Date 10 June 2016
Our ref 13853/02/DG/ADn/11268610v2
Your ref 2015/4510/P and 2015/4739/L

London Borough of Camden: Applications for Variation of Conditions attached to Planning Permission 2015/4510/P and Listed Building Consent 2015/4739/L at The Hill Bar & Brasserie, 94 Haverstock Hill, London, NW3 2BD

These applications seek to vary the above conditions to amend specific approved drawings (set out below), to modestly alter the approved detailed design.

Appendix 3: Comparison of approved south-west elevation and now proposed south west elevation (as seen behind the high-level decorative parapet)

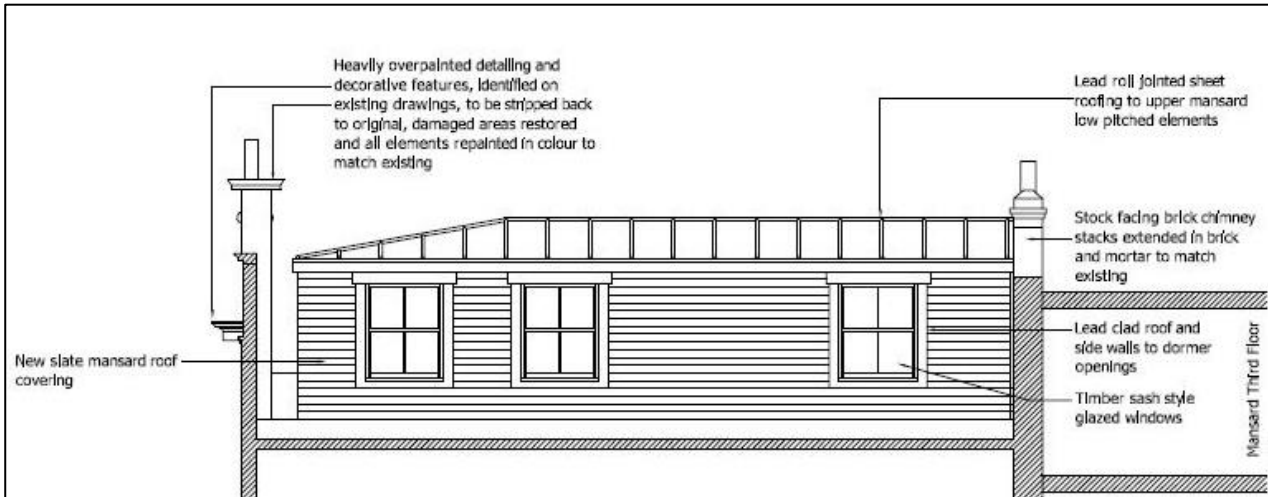
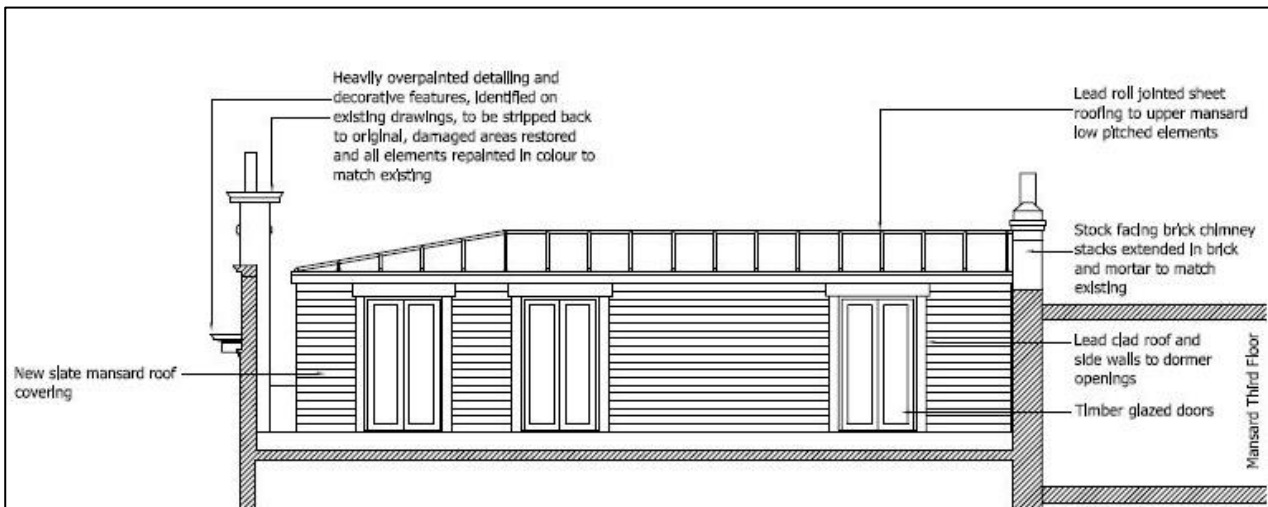
The applications seek to make a single change to change the consented dormer windows on the south-west elevation (behind the parapet) of the approved mansard roof extension, and to replace these with French doors to the same width and in the same locations. The doors would be glazed with timber frames and with lead clad roof and side walls as with the approved windows. All other details of the proposals as approved under 2015/4510/P and 2015/4739/L remain unchanged.

The proposed minor variation to the approved drawings are for the replacement of the three approved dormer windows on the south-west elevation (behind the parapet) to be replaced with three French doors in the same locations. This would result in a very minor alteration to the approved drawings.
